DATE: May 16, 2011
TO: Steve Lester
Idaho Department of Water Resources
FROM: Christian Petrich, Ph.D., P.E., P.G.
SPF File: 329.0051

RE: *Application for Permit 61-12256 – Response Regarding Water Supply and Availability*

Figure 3. Capture zone and tributary area to wells in the Mayfield Springs area (based on analysis for Permit 60-32225, SPF, 2007).

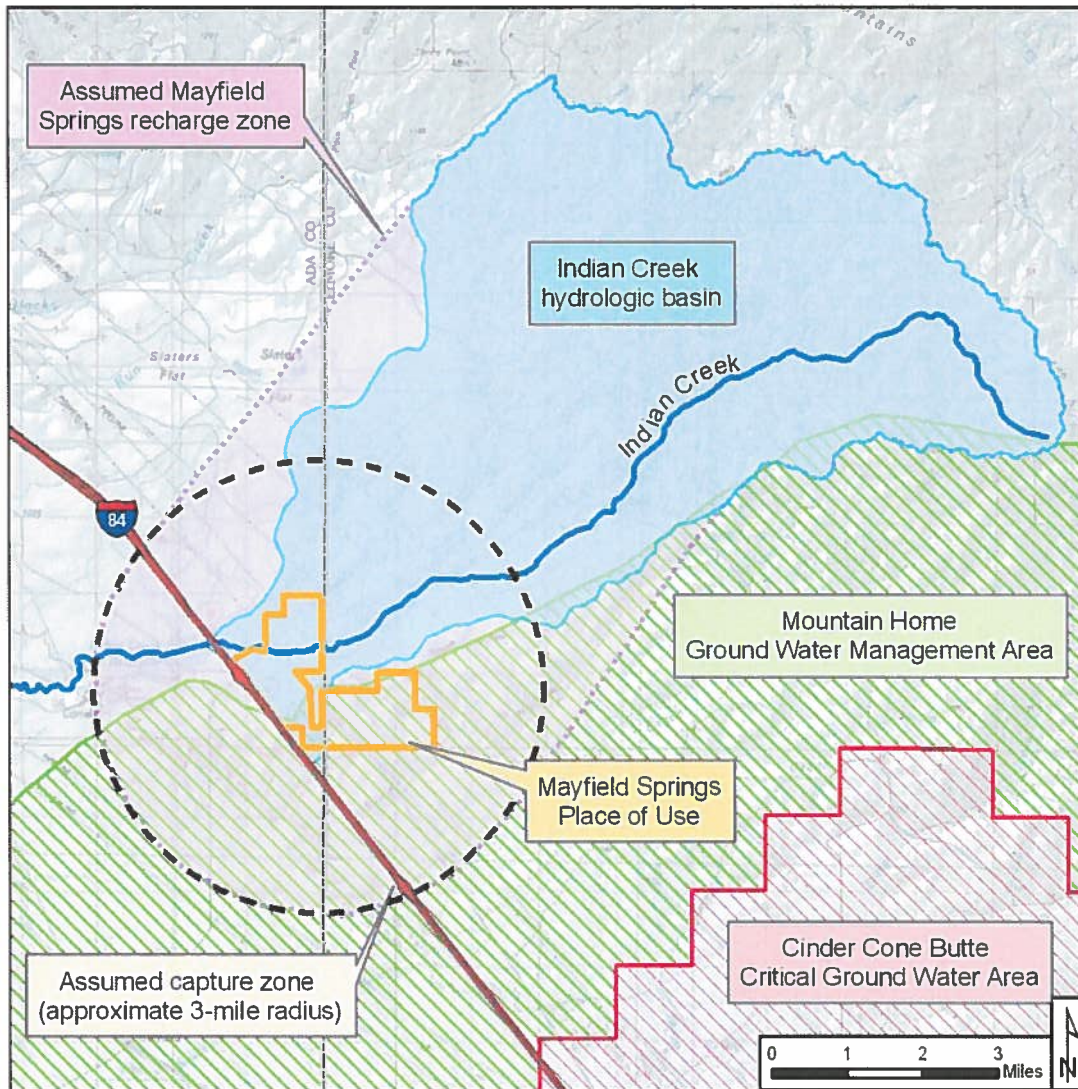
IDWR Question #4: Demonstrate an adequate, sustainable ground water supply is available, and demonstrate the proposed use of ground water will not result in further ground water level declines in the Mountain Home Ground Water Management Area or the Cinder Cone Butte Critical Ground Water Area.

Diversions in 2007 within the Mayfield Springs capture zone (Figure 3) were estimated to be approximately 700 acre-feet per year (SPF, 2007). Permit 63-32225 authorizes a maximum annual withdrawal of 1,815 acre-feet for the Mayfield Springs Planned Community. Application for Permit 61-12256 will require an additional 2,700 acre-feet per year for the Mayfield Springs Planned Community. These combined volumes (5,215 acre-feet per year) are less than the recharge range projected in 2007 (SPF, 2007).

In summary, the proposed annual diversion under Application for Permit 61-12256 and other known annual diversions (see also Section G) – a total of approximately 6,300 acre-feet per year (based on currently available information) – are less than the estimated range of average recharge (8,600 to 32,600 acre-feet per year) estimated in 2007 (SPF, 2007). The applicant intends to provide an updated estimate of sustainable water supply pending the outcome of current data collection efforts.
